Groundwater Application Review Summary Form

Application # G- 18717

To: Kristopher Byrd, Well Construction and Compliance Section Manager
From: Joel Jeffery, Well Construction Program Coordinator,
Subject: Review of Water Right Application G-18717
Date: March 15, 2019

SUBJECT: Application G- 18717

Well Location Map

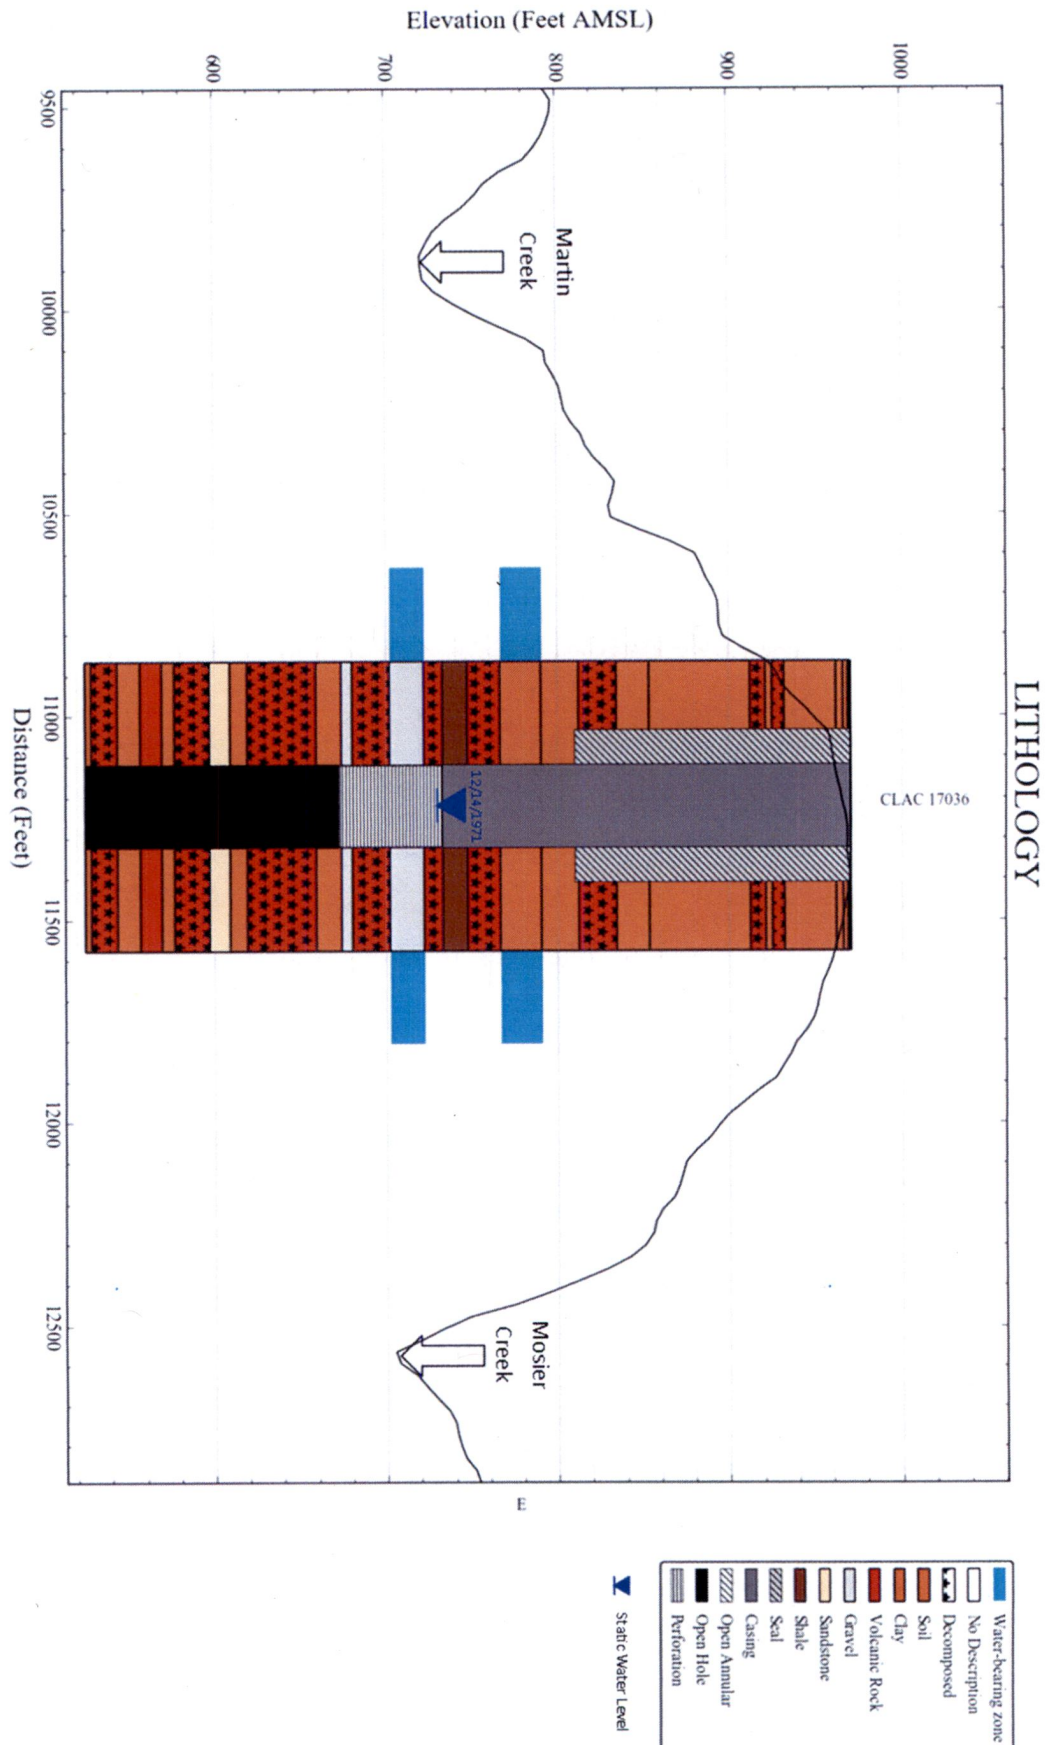
A4. **Comments:** The requested POA/POU is located approximately 3.75 miles southeast of the unincorporated community of Beavercreek, Oregon.

Comments: C3a: CLAC 17036 is within ¼-mile (1,320 ft) of both SW 1 (Mosier Creek) and SW 2 (Martin Creek), to which it is hydraulically connected. Therefore, per OAR 690-09-0040(4)(a), the requested POA is assumed to have the potential to cause substantial interference with these surface water sources. NOTE: No part of the proposed place of use (Clackamas County Tax Lot No. 202) is greater than ¼-mile from a hydraulically-connected surface water (see “Well Location Map”, attached). There does not appear to be an alternative location within the requested place of use which would not be assumed to have the potential to cause substantial interference between the alluvial aquifer and nearby surface water.

WELL CONSTRUCTION & LITHOLOGY – POA 1 (CLAC 17036)

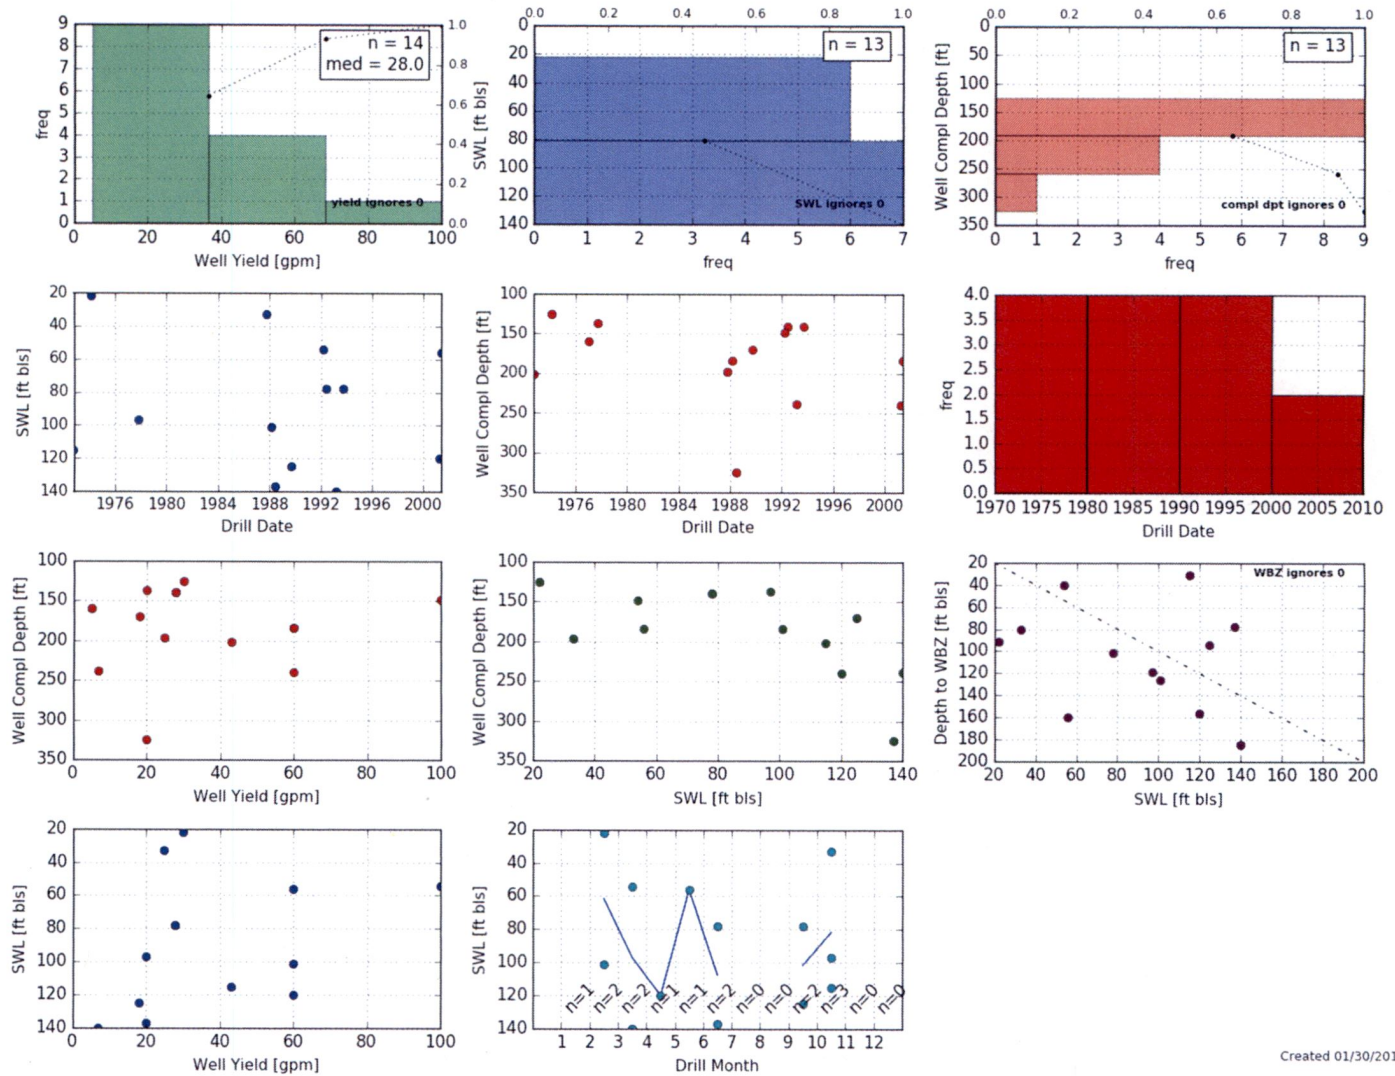
Applicant's Well #1 (CLAC 17036): Based on a review of the well report, Applicant's Well #1 does not appear to comply with current minimum well construction standards (See OAR 690 Division 210). The well report indicates that cement, bentonite, and cuttings were used for the annular seal. Cuttings are not an approved annular seal material. In addition, the annular seal does not extend far enough below land surface. In order to meet minimum well construction standards, the well must be recased and resealed to a minimum depth of 228 feet below land surface with an approved grout.

According to the Water Well Report for CLAC 17036 (the requested POA), the applicant's well appears to produce water from an approximately 20 ft thick layer of water-bearing gravel between 248 and 268 ft below land surface (bls) (elevations of approximately 718 ft to 698 ft above mean sea level [msl]), although water-bearing sandy clay was noted as extending from a depth of approximately 180 to 204 ft bls (elevations of approximately 786 ft to 762 ft above msl) (see Well Construction & Lithology, attached). This sandy clay was not sealed off and therefore may be in hydraulic communication with CLAC 17036 via the borehole annulus.

My recommendation is that the Department **not issue** a permit for Applicant's Well #1 (CLAC 17036) unless it is brought into compliance with minimum well construction standards or information is provided showing that it is in compliance with current minimum well construction standards.
